Enough is Enough

a report submitted by the
Canadian Coalition for Nuclear Responsibility
to the
Canadian Nuclear Safety Commission

regarding OPG's requested
authorization for the
Proposed Pickering B Refurbishment

August 12 2026

Fig. 4. Radioactivity in the environment from different elements, for an unmitigated SBO severe accident.

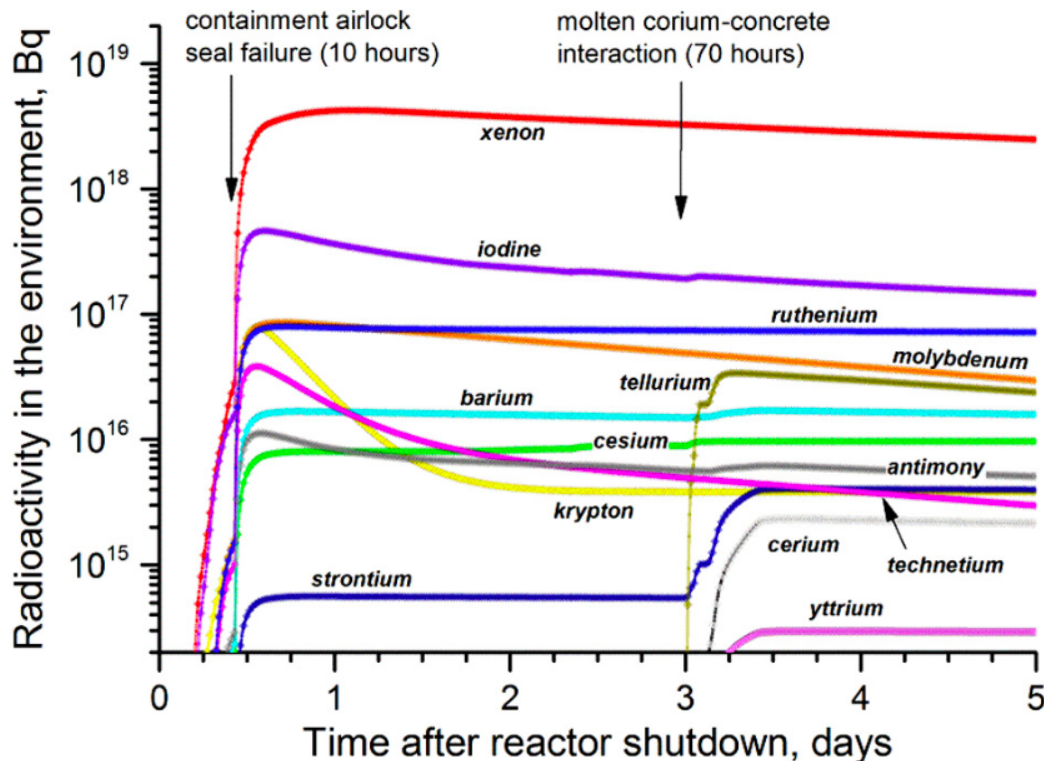
Below is a graph from a scientific research paper authored by four staff members from Canadian Nuclear Laboratories (CNL) and one from the Canadian Nuclear Safety Commission (CNSC). The graph indicates a radioactive release into the environment following a postulated CANDU nuclear accident – an unmitigated total station blackout.

The cesium-137 component (indicated in bright green) in this postulated release is at least 80 times greater than that proposed in the 2015 CNSC report. On the vertical scale, 10^{16} becquerels is equal to 10,000 terabecquerels; that is 100 times greater than the 100 terabecquerels indicated in the CNSC report cited above. Why the discrepancy?
